R.J. Adney
Site Vice President
Sequoyah Nuclear Plant

SEQUOYAH NUCLEAR PLANT (SQN) - PREDECISIONAL ENFORCEMENT
CONFERENCE (EA 96-269)

The following information was requested at the Predecisional Enforcement Conference held on October 24, 1996 regarding the SQN fire protection program.

FIRE SAFE SHUTDOWN CABLES IN THE OLD HOT TOOL ROOM

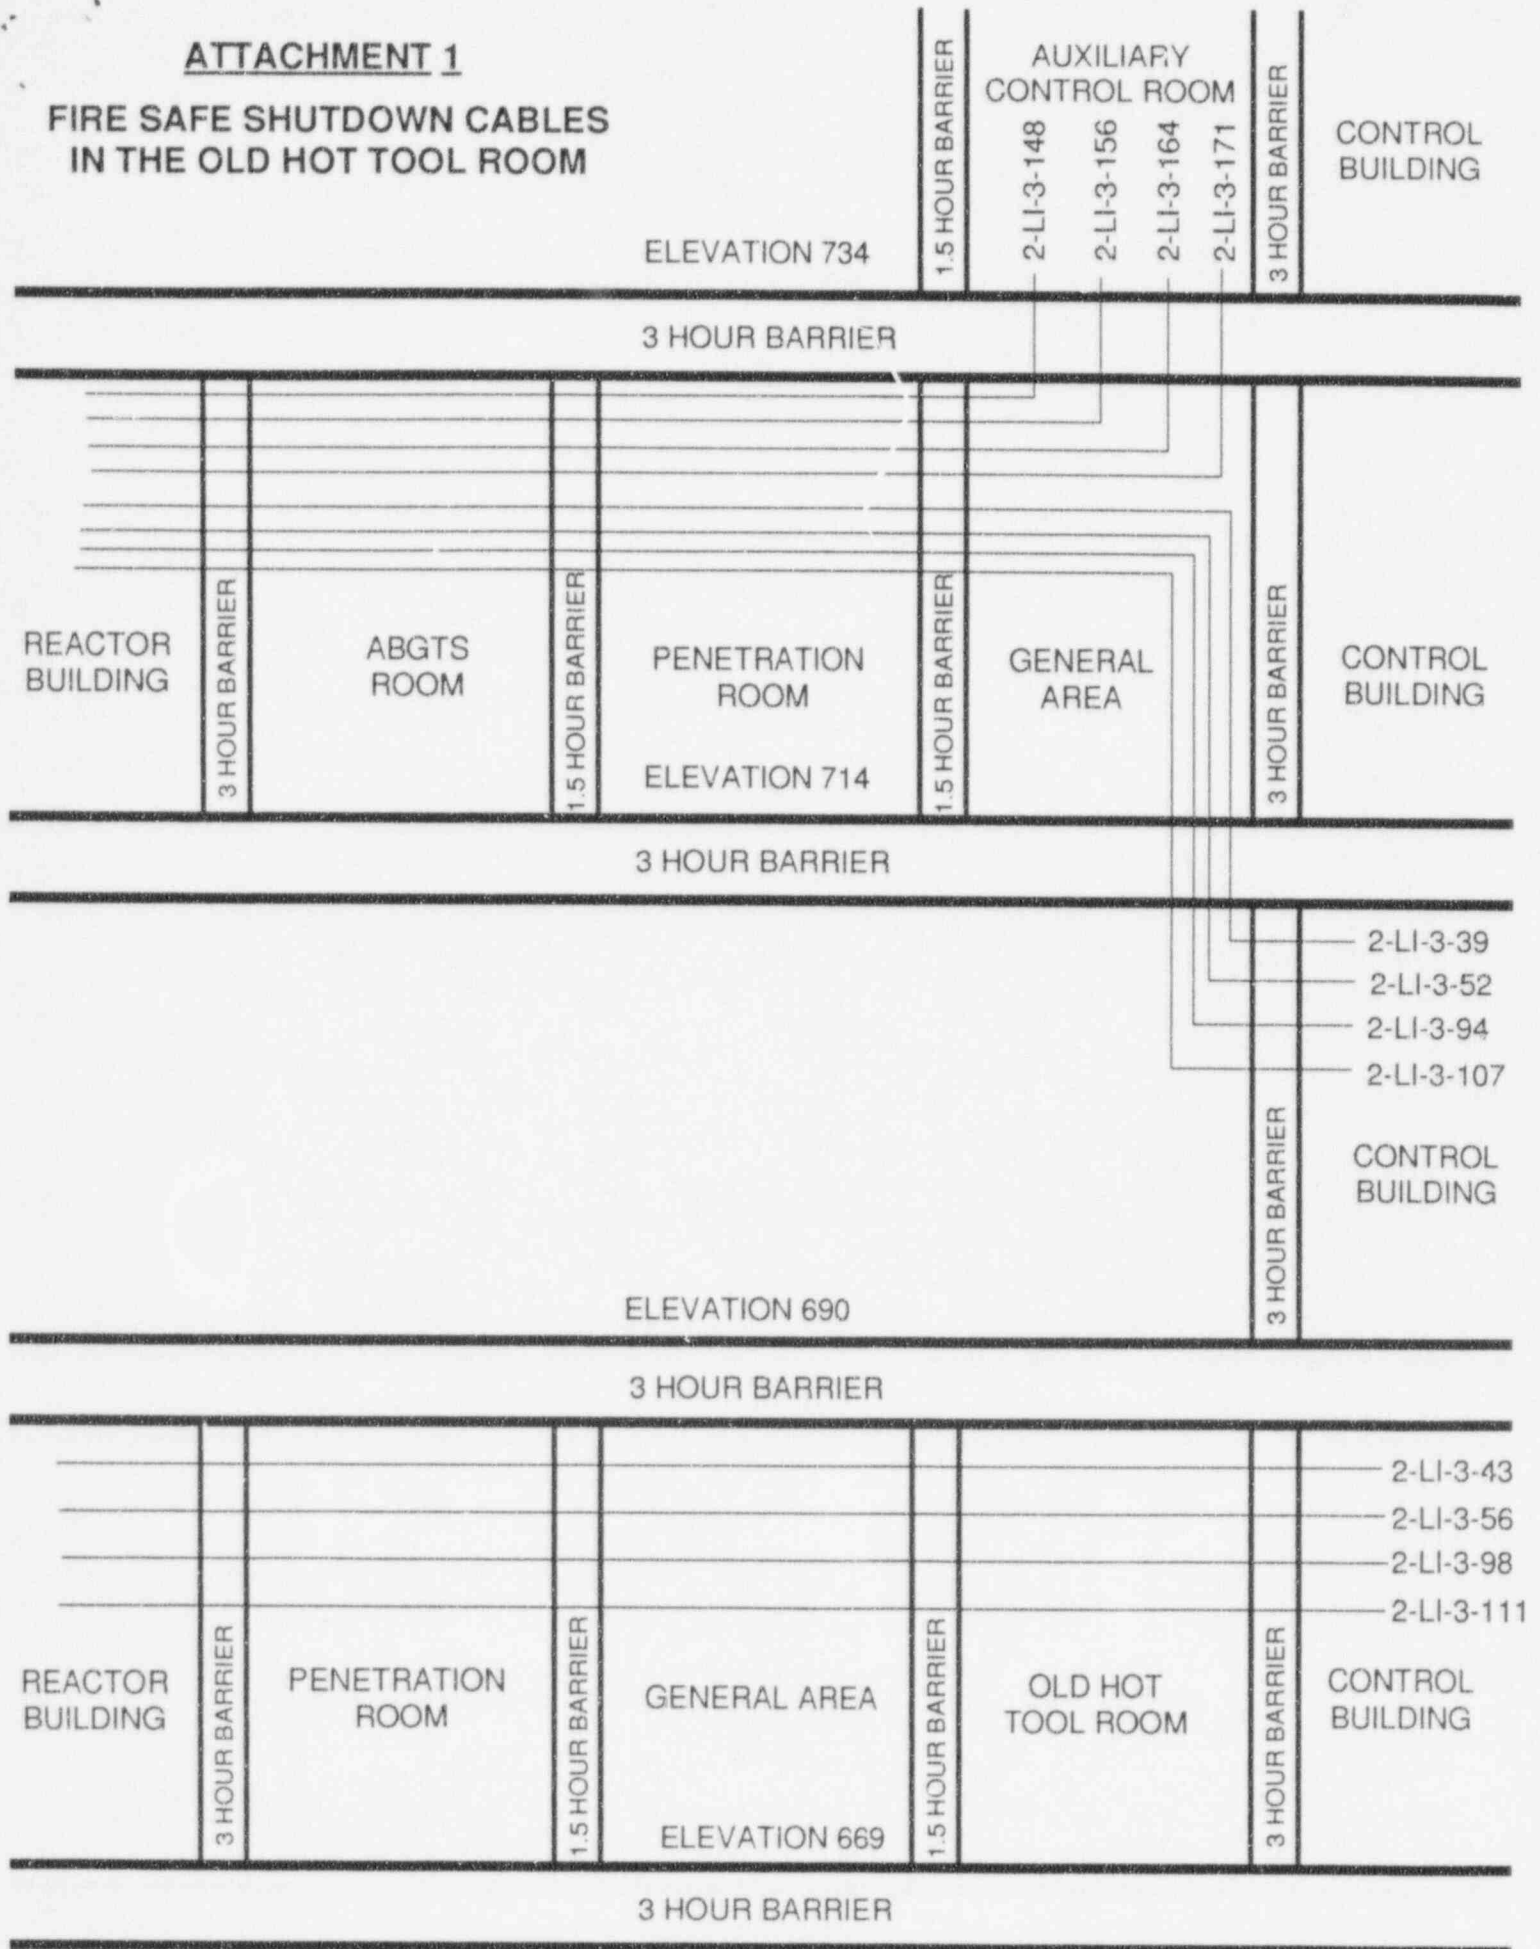
What are the safe shutdown or safety-related cables in the spare room on elevation 669 of the Auxiliary Building?

The only safe shutdown or safety-related cables in the spare room on elevation 669 of the Auxiliary Building are four steam generator (S/G) level cables. These cables are associated with only one of the three fire-safe shutdown S/G level indication circuits. Therefore, in the event of a fire in that room, a three-hour rated fire barrier prevents the fire from interacting with the two redundant channels of S/G level indication (routed on elevations 690 and 714 of the Auxiliary Building). This three-hour fire barrier provides the separation required to comply with 10 CFR 50, Appendix R, Section III.G.2.a. The ability to safely shut down the plant is not impacted by this condition. Attachment 1 provides a sketch of the S/G level cable routing.
